STATE OF CALIFORNIA • DEPARTMENT OF TRANSPORTATION
NOTICE OF POTENTIAL CLAIM
CEM-6201 (REV 3/2001)

TO Doug Coe (resident engineer) CONTRACT NUMBER 04-012024 DATE 06/04/02

Subject: Minimum Segment Age for Frame 3 Exterior Closures

SAN FRANCISCO OAKLAND BAY BRIDGE
EAST SPAN SEISMIC SAFETY PROJECT

SKYWAY STRUCTURES
CONSTRUCTION SEQUENCE NO. 1

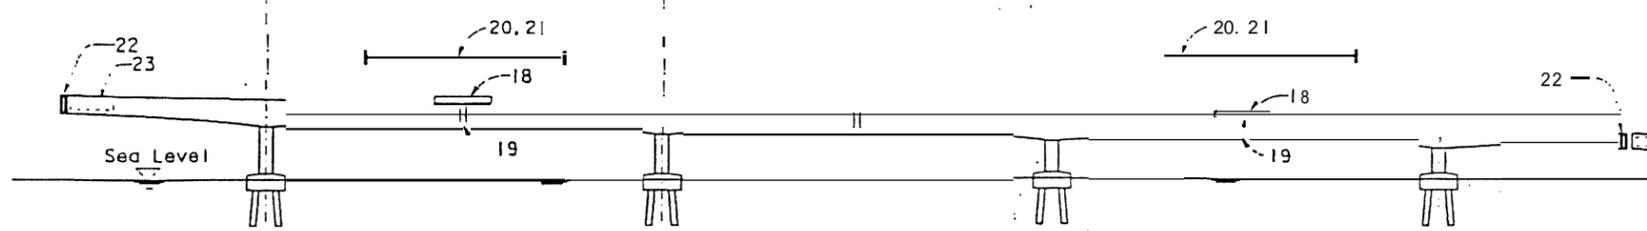
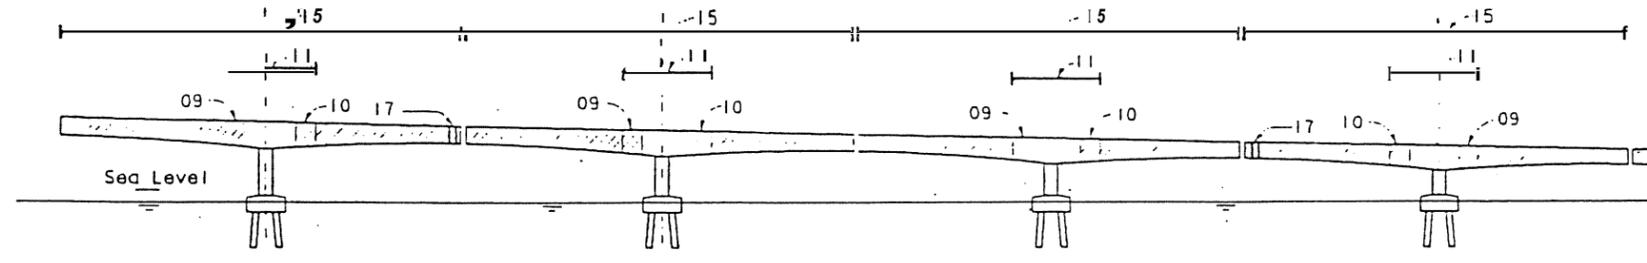
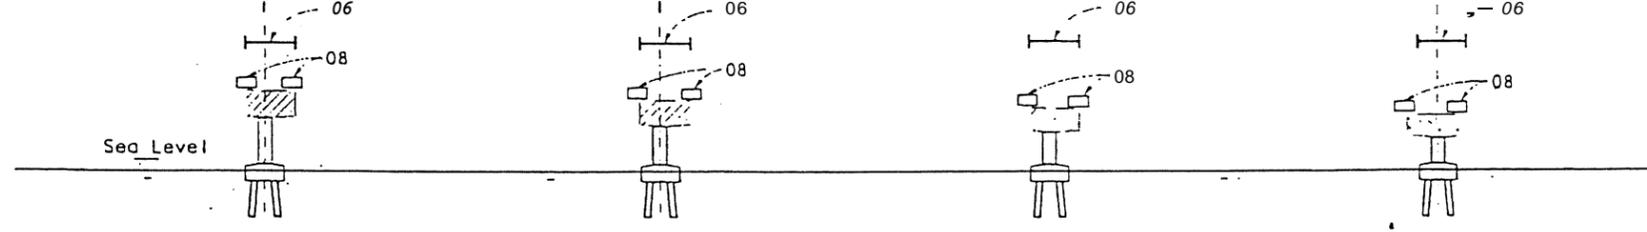
27. Sheets 917 and 918 of the contract plans address the aging requirements of the cast segments for both the external and the internal closures. Casting of the segments within Frame 3 do not support the 18 months aging requirements for the exterior closures in both the eastbound and westbound. Resequence the respective activities to support the aging requirements.

KFM does not agree with the State that sheets 917 and 918 of the contract plans (Attachment “A”) represent an 18-month aging requirement for the exterior closures in Frame 3 for both eastbound and westbound. While sheet 918, in the “Closure and Jacking Schedule”, clearly requires an 18-month segment age for the *interior* closure of Frame 3 at E13W and E13E, there is no specific duration given on either sheet for the segment age for the *exterior* closures. If provided, this duration for segment age would have been designated as, and specified for, E12W, E14W, E12E, and E14W.

The only specific reference on these sheets to the segment age with regard to the exterior closure is in Step 19, on Sheet 917. Step 19 states the segment age at the time of exterior closure will be in accordance with the “Closure and Jacking Schedule” in the “Construction Sequence No. 2” sheet, which is Sheet 918. Again, the “Closure and Jacking Schedule” on sheet 918 only specifies the segment age requirements for the *interior*, not the *exterior*, closures for Frame 3.

84. Concerning segment age at time of closure, please reference plan sheet #917 of 978, note #19. Is it the owner’s intention to hold the contractor to the same requirements for concrete age for the exterior closures as is imposed for the interior closures (18 months)? Currently, the interior closure construction is predicated on reaching the segment age of 2, 6 or 18 months depending upon the span.

Attention is directed to Addendum #7.
